# CITY OF ALBUQUERQUE

**Re: Stripes Burrito CO.  
2781 57<sup>TH</sup> St. NW  
30-Day Temporary Certificate of Occupancy  
Transportation Development Final Inspection  
Architect's Stamp dated 05-31-22 (H11-D073)  
Certification dated 07-02-24**

Sheet: Traffic Circulation Layout

1 Site Plan-  
Scale: 1" = 20'-0"

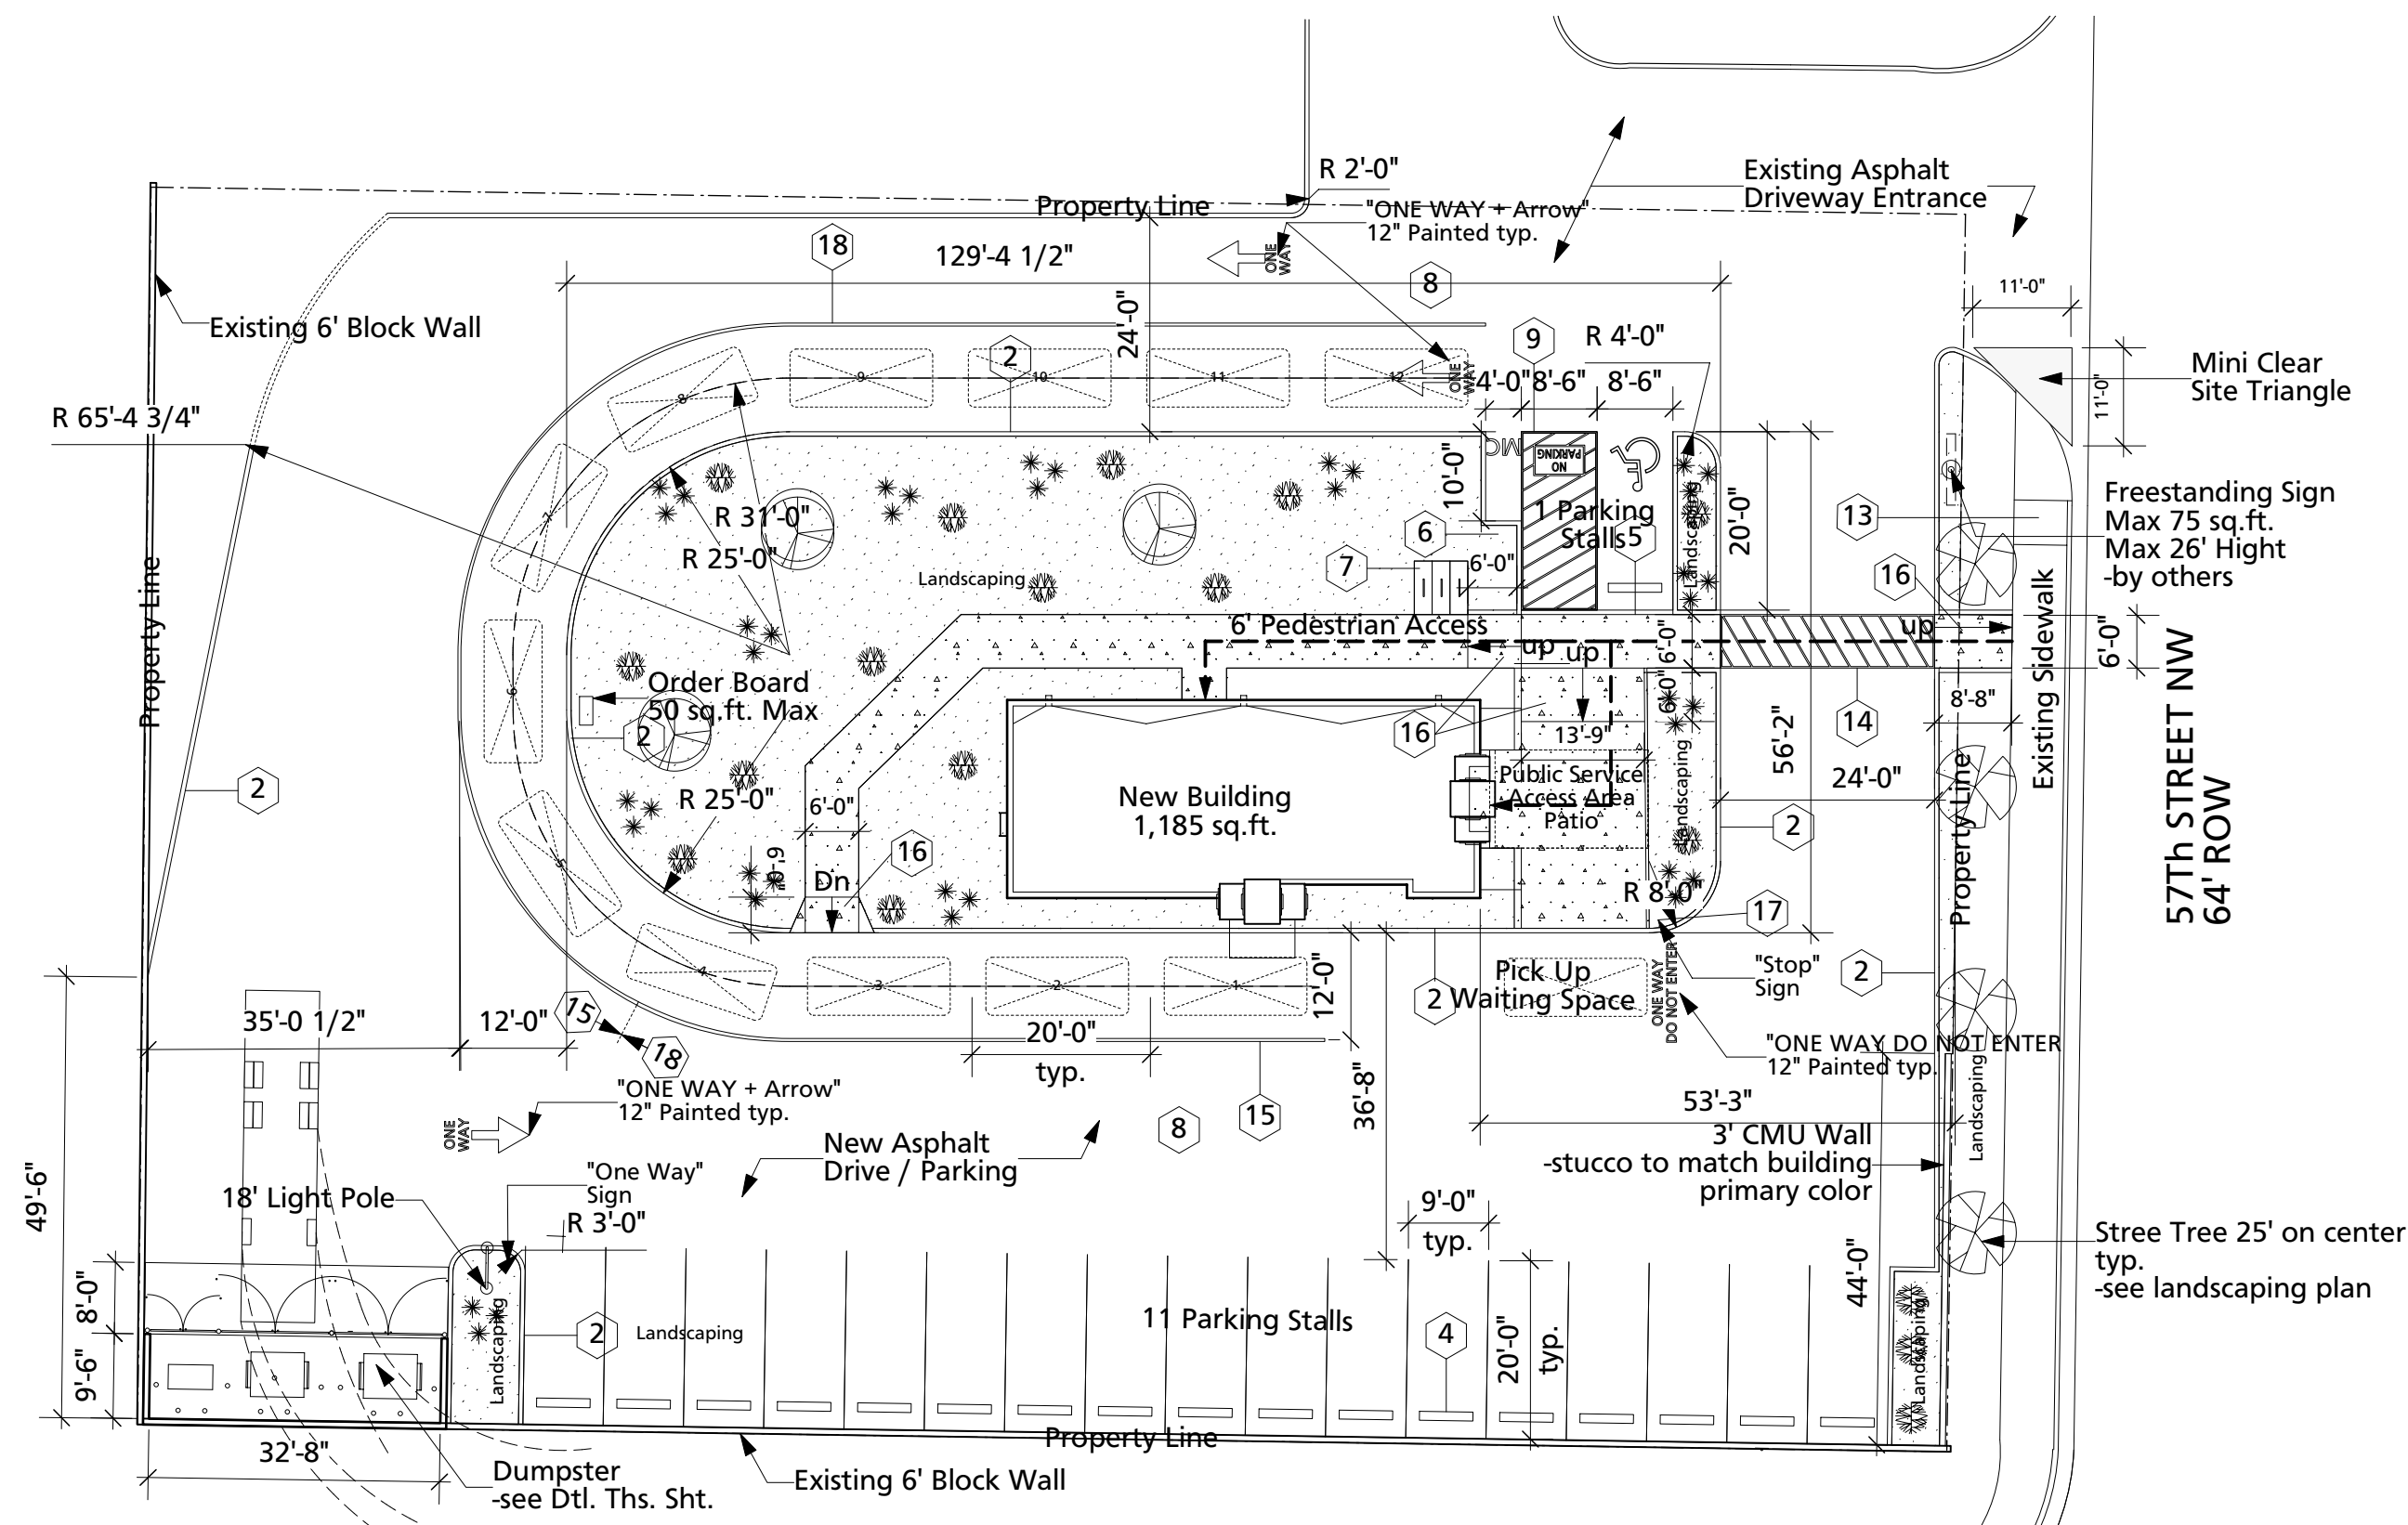
- Per approved site plan, please provide the "ONE WAY" pavement marking at the beginning of the drive-thru and the "DO NOT ENTER" pavement marking at the exit of the drive-thru lane.

6 HC / Motorcycle / One Way Sign Detail  
Scale: 3/4" = 1'-0"

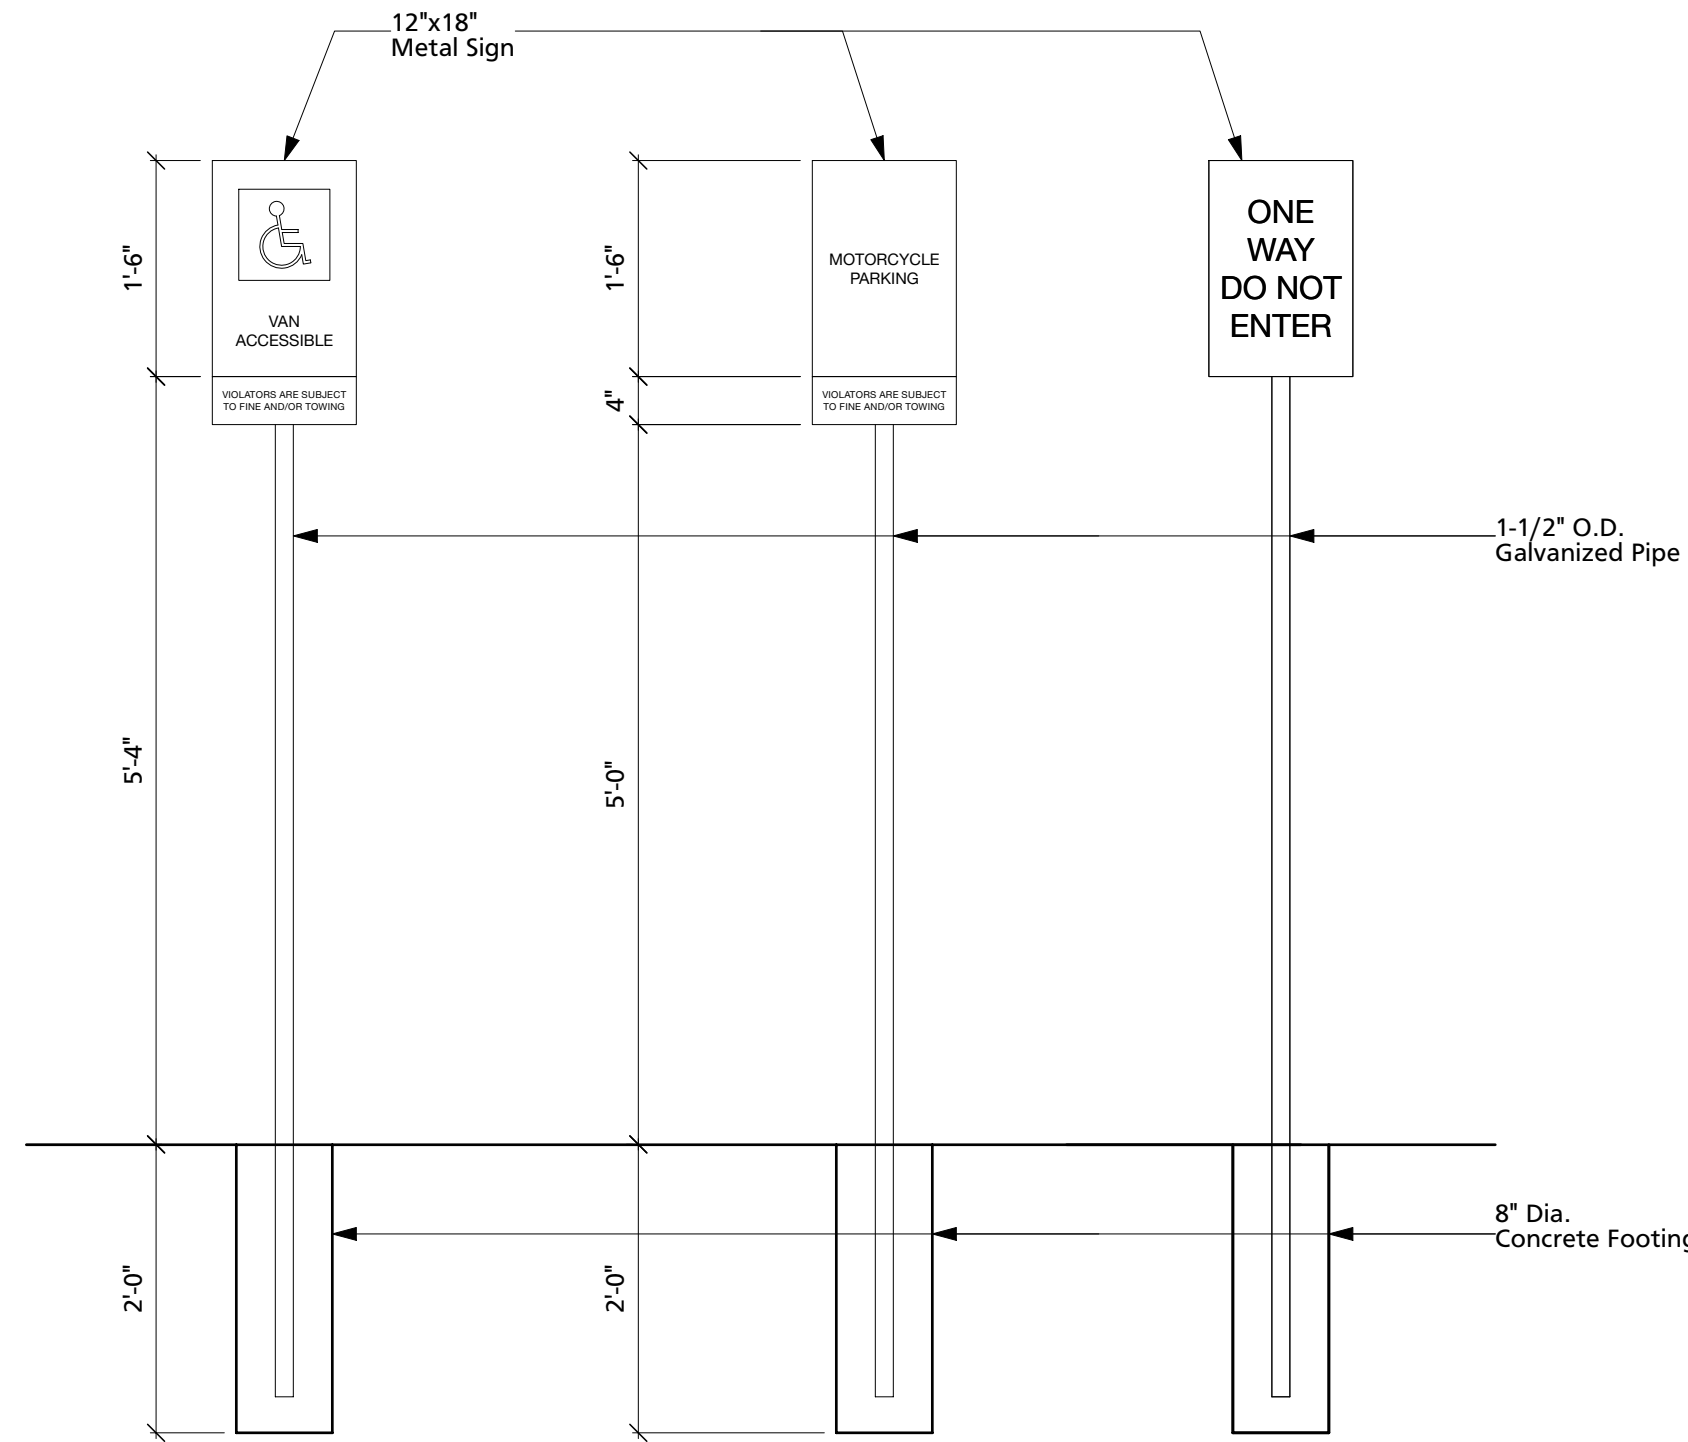
- The ADA accessible parking sign must have the required language per 66-7-352.4C NMSA 1978 **"Violators Are Subject to a Fine and/or Towing."** Please call out detail and location of signs.
- Per city requirements, ADA parking aisle must be striped with blue.

- Provide Motorcycle parking space sign.
